Transmission for Broadcast Management Message (15.3.6.5.4.1)

IEEE C802.16m-09/1983

IEEE 802.16m-09/0044, "Letter Ballot #30"

Area: "15.3.6 Downlink control structure".

Illustration of Proposal

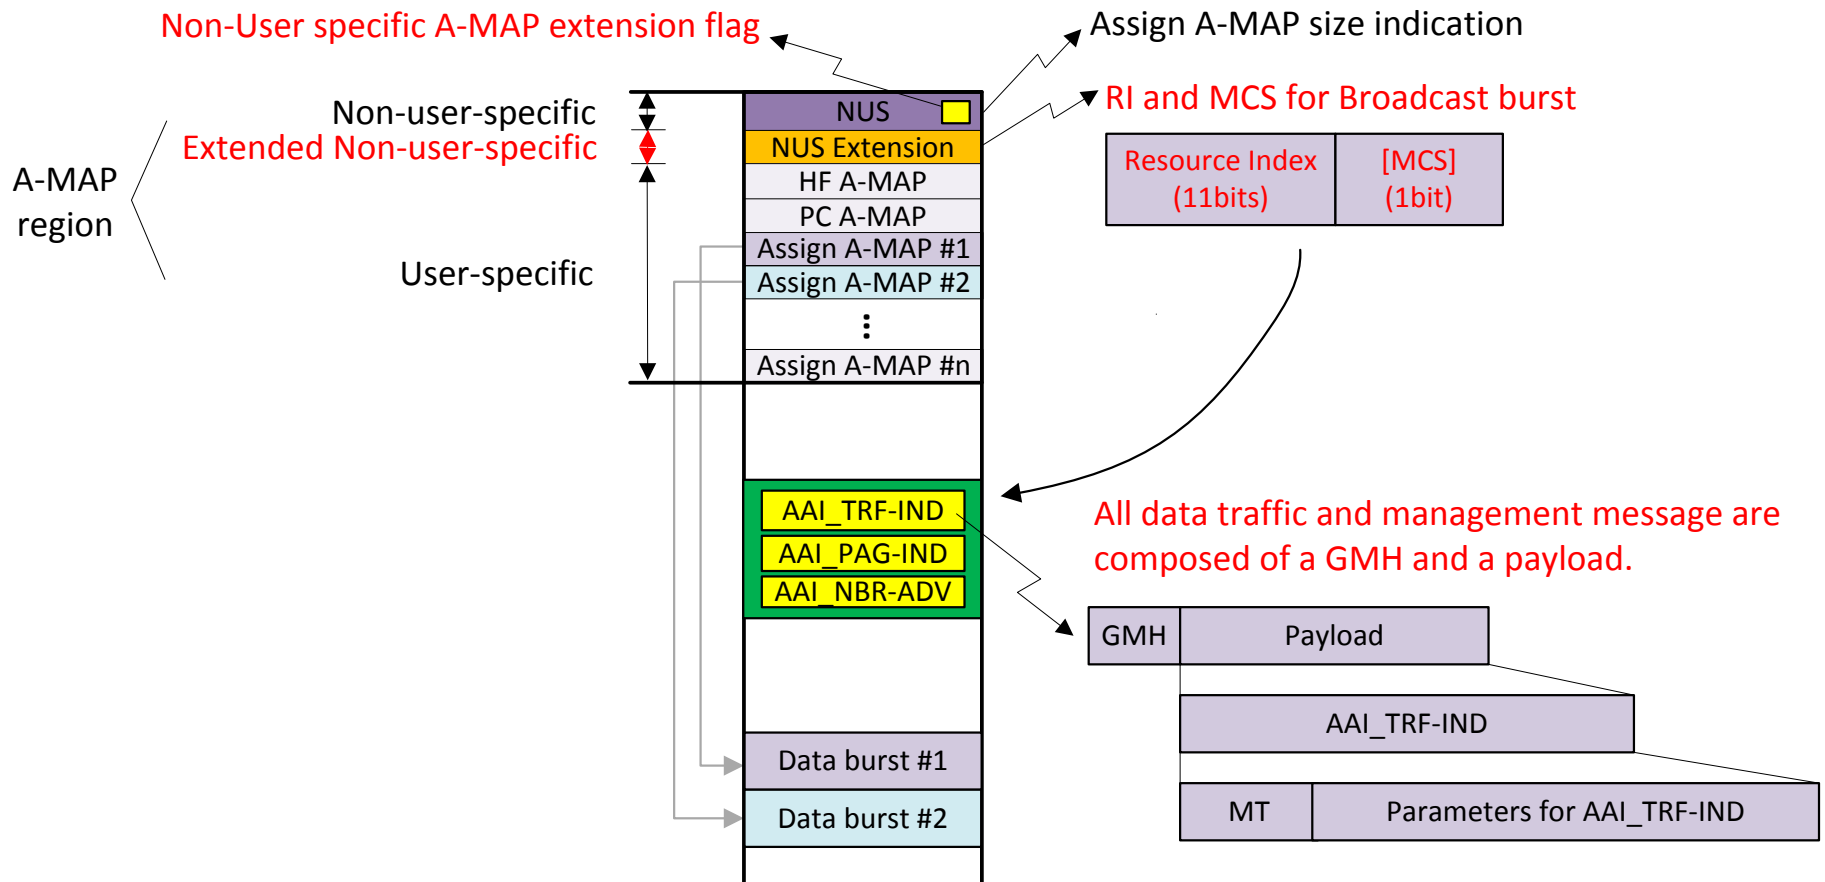
▪ **Extended NUS A-MAP IE contents (12bits)**

- Resource index (11 bits): identical to RI in DL Basic A-A-MAP IE
 - Flexible allocation is possible: minimize collision with PA or Long TTI burst
- [MCS level] (1 bit)

▪ **Broadcast burst transmission**

- One broadcast burst includes one or multiple broadcast management messages
- AMS delineates the boundary of each MAC PDU (management message) in the broadcast burst by decoding its GMH
- AMS identifies the type of broadcast management message by referring to message type (MT) in each MAC PDU
